NOTICE OF PROPOSED DEVELOPMENT

7 RENMORE COURT, CARLTON

DWELLING

Re: 5.025.178 at 7 Renmore Crt Carlton

TYPICAL DRIVEWAY CROSS SECTION
- Roadbase only driveway < 18% slope, parrallel, or approx., to contours

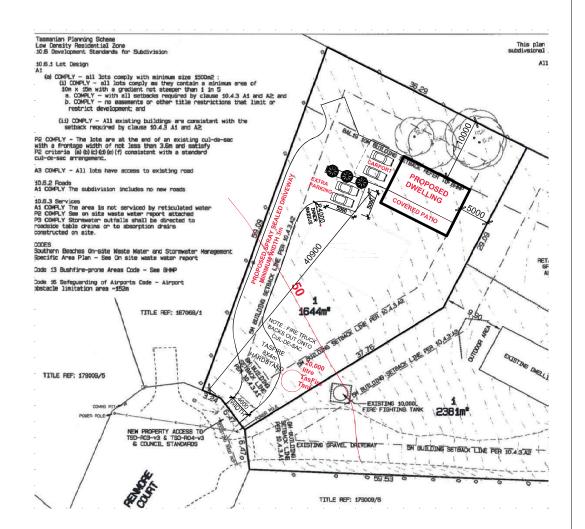
Please provide sectional detailed design of proposed material on internal driveway area showing thickness of material - C2.6.1

RESPONSE: The driveway construction sections are now shown on the site plan DWG-02 /C

SITE PLAN

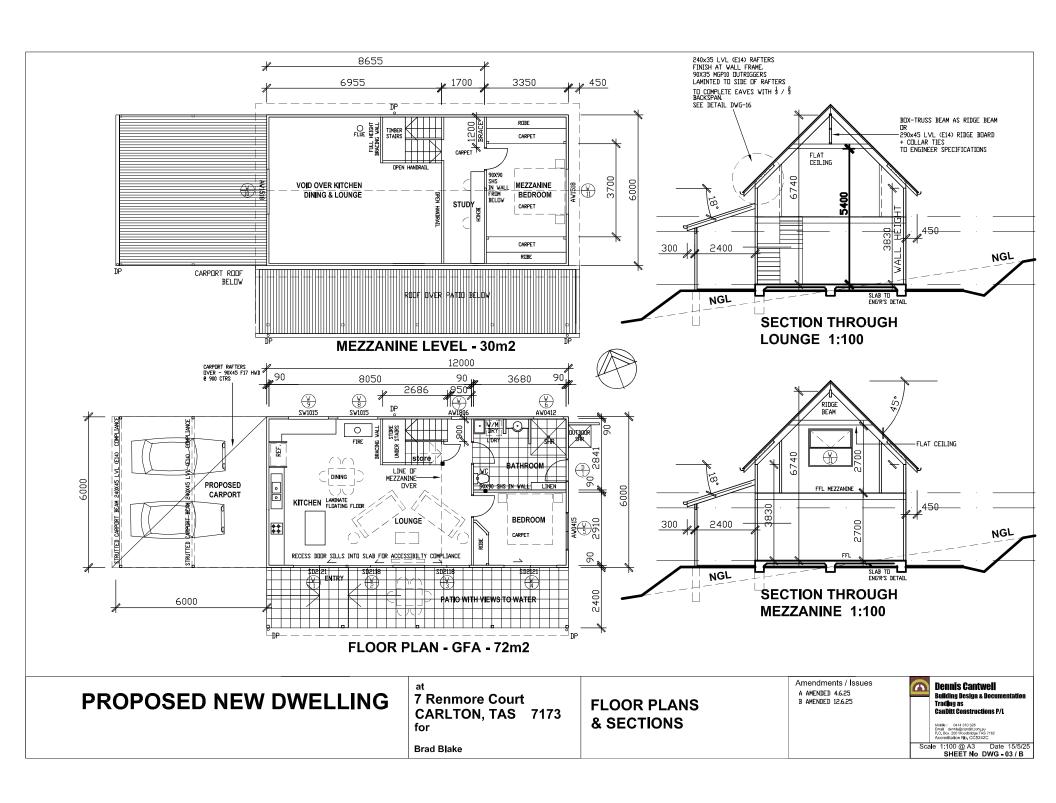
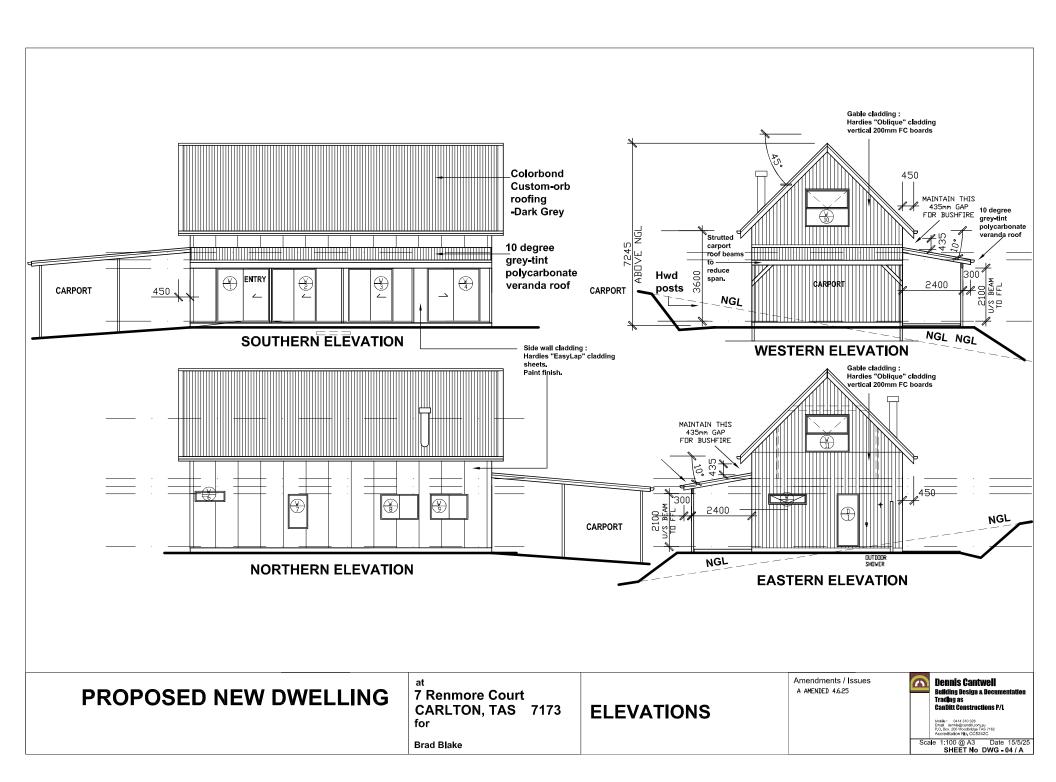
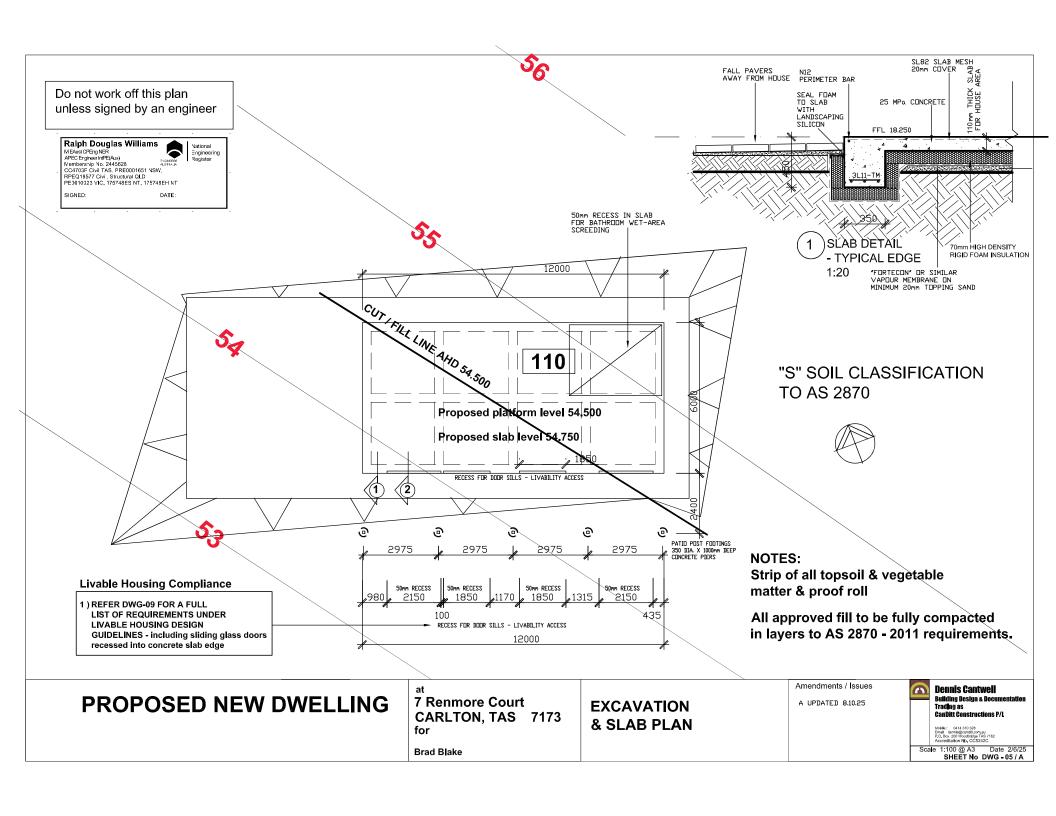
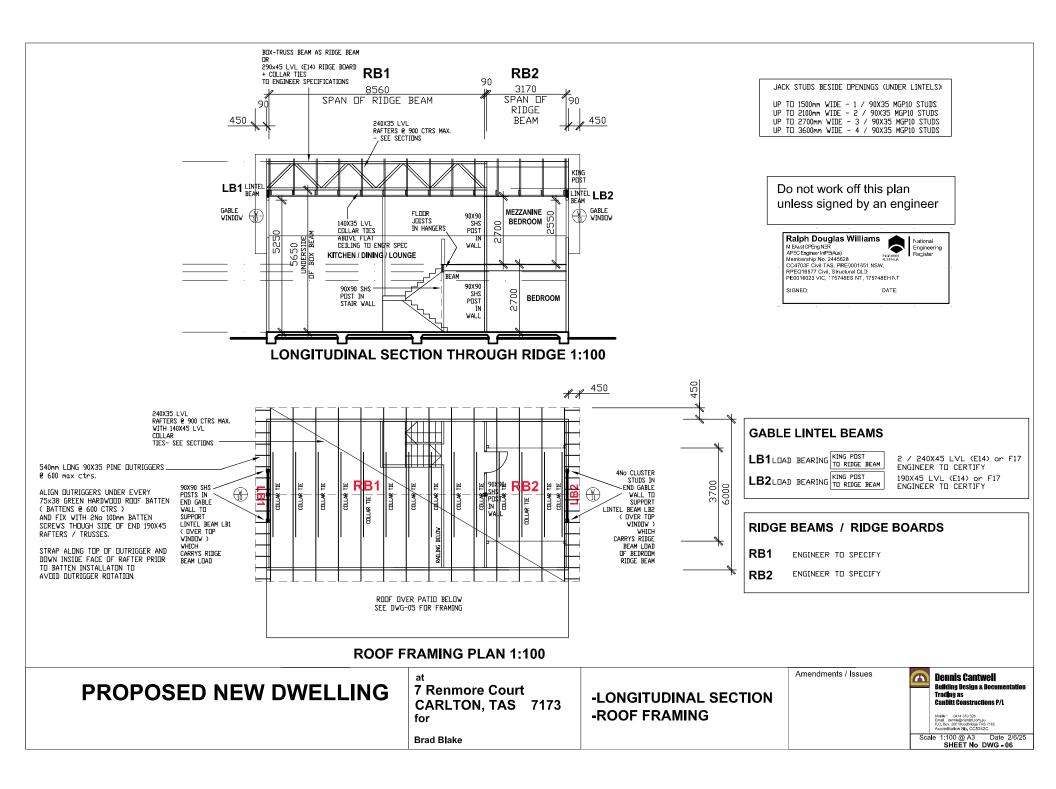
2. Please detail on plan showing minimum access width - C2.6.2

RESPONSE: This is now shown on the site plan - minimum access width at crossover 4m & 3m min width driveway. Note: The driveway is too short for passing bays every 30m.

Please note the plan is to limit TasFire truck access to a hardstand just inside the frontage, where a TasFire static 20,000 litre water tank (upgraded by owners from the usual 10,000 litres) will be located as per the subdivision bushfire report. TasFire hoses will reach to up behind the proposed house, being < 90m, the maximum fire hose reach.
